# CITY OF SAN ANTONIO

Re: **Canyon Crossing**

**MDP # 857**

The City Staff Development Review Committee has reviewed **Canyon Crossing** Master Development Plan **M.D.P. # 857**. Please find enclosed a signed copy for your files. Your plan was accepted however please note the following:

**CANYON CROSSING**  
 MASTER DEVELOPMENT PLAN

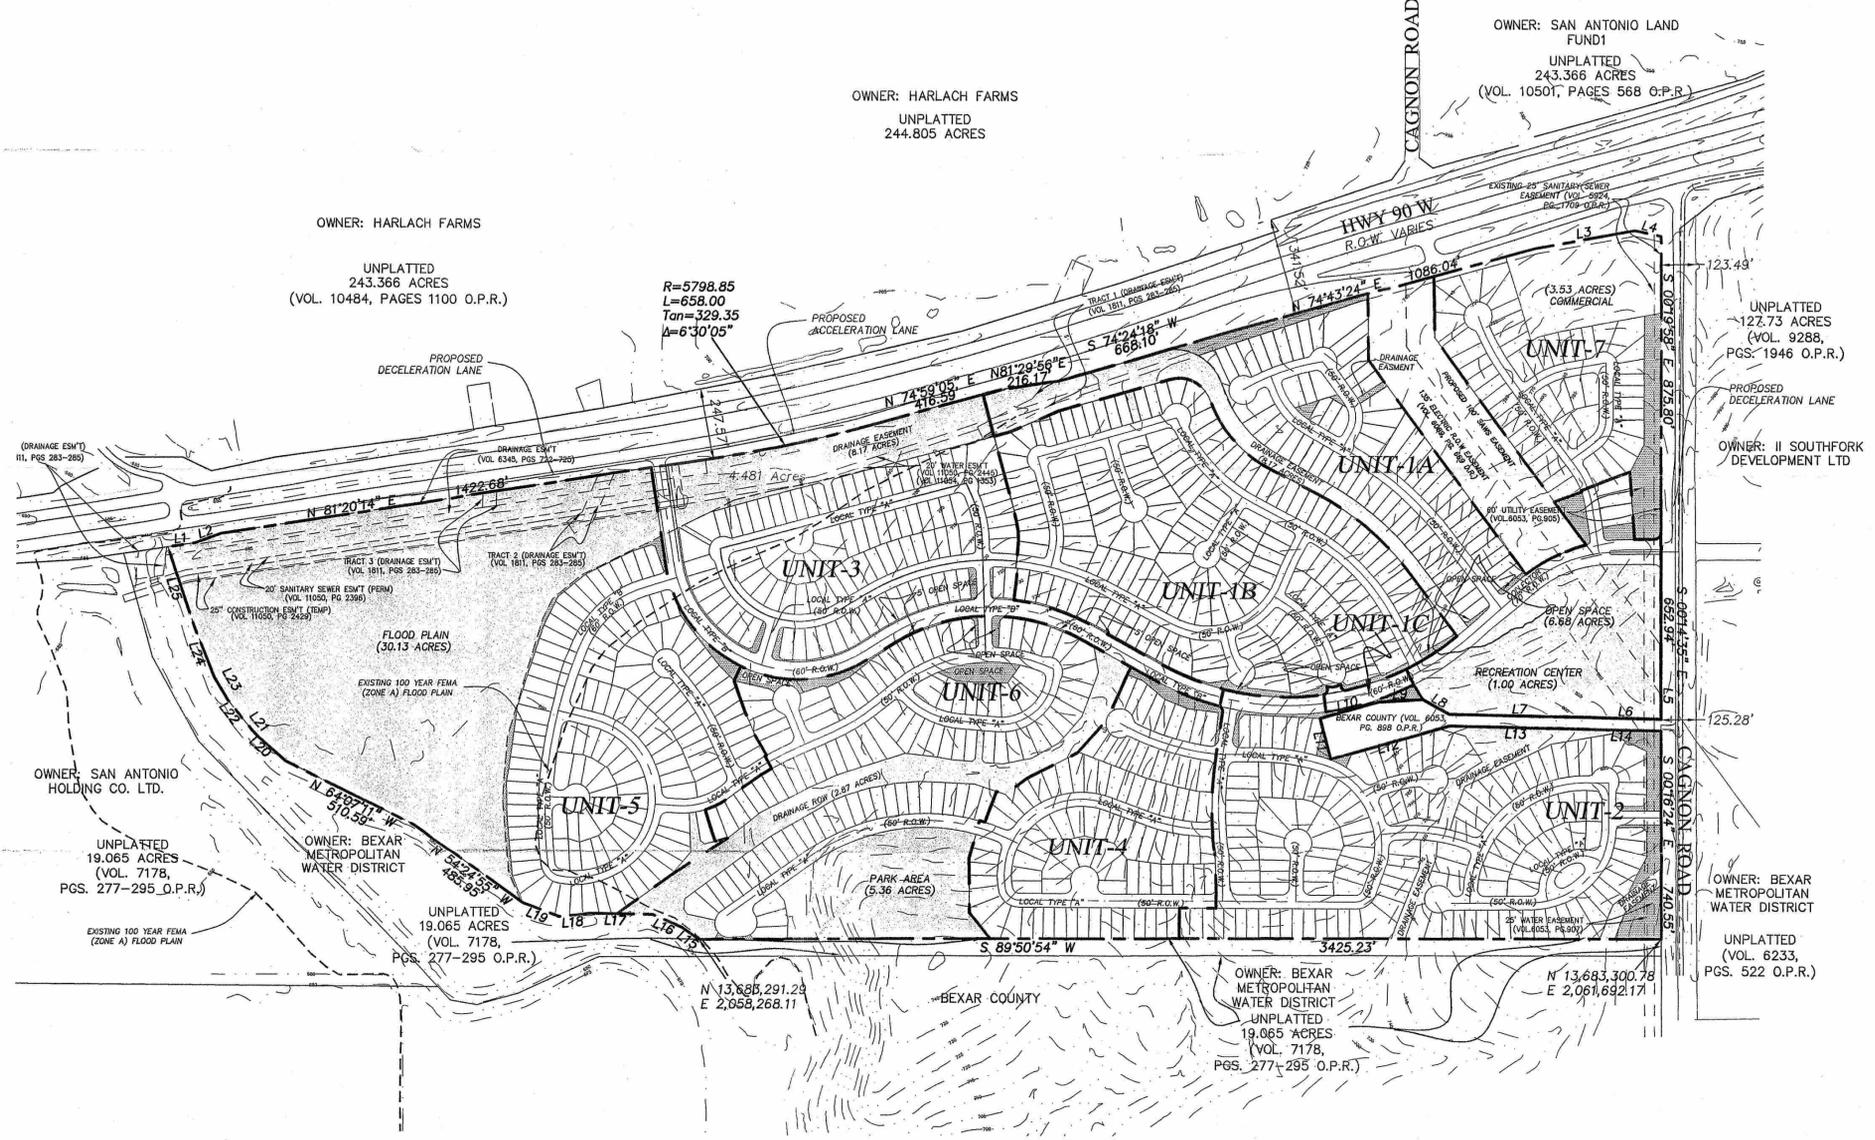
- In consideration of public safety and convenience, excessive grades by reason of topography should be avoided in street layouts and arrangements.
- Any access and R.O.W. issues along state facilities will need to be resolved with the **Texas Department of Transportation (TXDOT)**. For information about these requirements you can contact TXDOT at 615-5814.
- **Historic Preservation:** The information submitted for the above-referenced request has been reviewed by the San Antonio Historic Preservation Office (HPO) staff according to the city's Historic Preservation and Design Section of the Unified Development Code (Article 6, 35-630 to 35-634).

- All roadways shall follow Table 506-7, Functional Classification System Description and shall comply with UDC 35-502(a)(9). All access roadways shall provide clear sight distance on all existing and proposed roadways in order to provide adequate obstruction free viewing distances for approaching traffic. All signage, landscaping, and improvements shall be selected and located so as to not block these clear sight distance areas.

- The developer shall be responsible for providing right-turn deceleration lanes as well as left turn lanes, with storage lengths and bay taper as it relates to the approved MDP and submitted TIA traffic counts, (Uniform Development Code (UDC) - 35-502 (a)(7), subsection C.

- Cul-de-sacs greater than 500 feet in length require a 30-foot pavement width with a minimum 50-foot pavement radius with no island. (See the cul-de-sac in Unit-4 next to the park area).

- Provide southbound right-turn deceleration lane for the primary access on Cagnon Road at Street B.
- Provide deceleration and acceleration lanes for eastbound US 90 at Street B as per TxDOT standards.
